ZONING REVIEWED

ROUNDEL HOMES INC. (PH-2)

LOT No. 65

CURRENT DRIVE

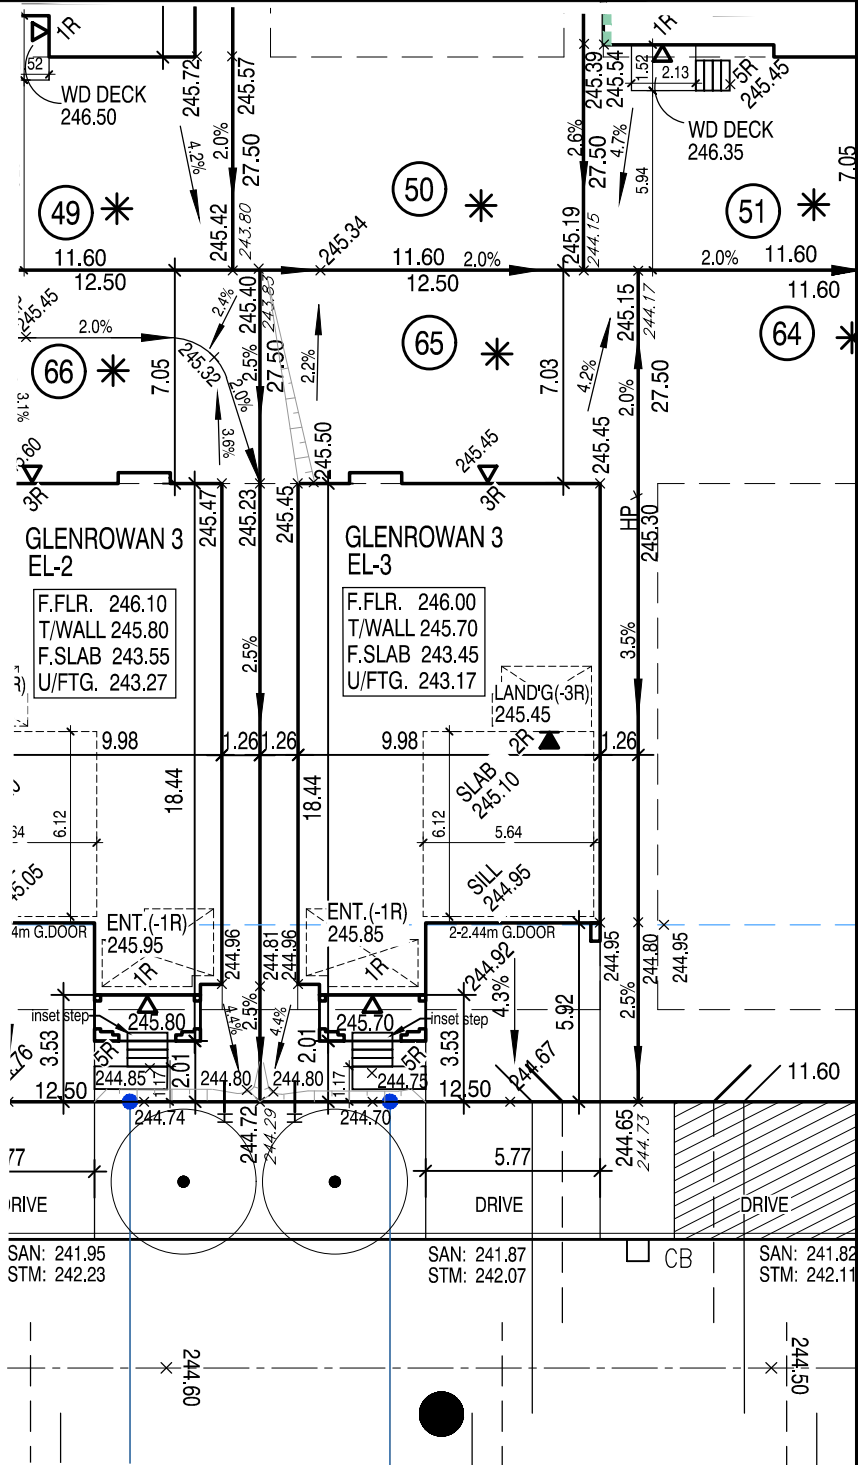
No unprotected openings permitted within 1.2 metres of the lot line as per 9.10.14 of the Ontario Building Code.

45 MINUTE RATED WALL
WITH SIDE YARD < 1.2m
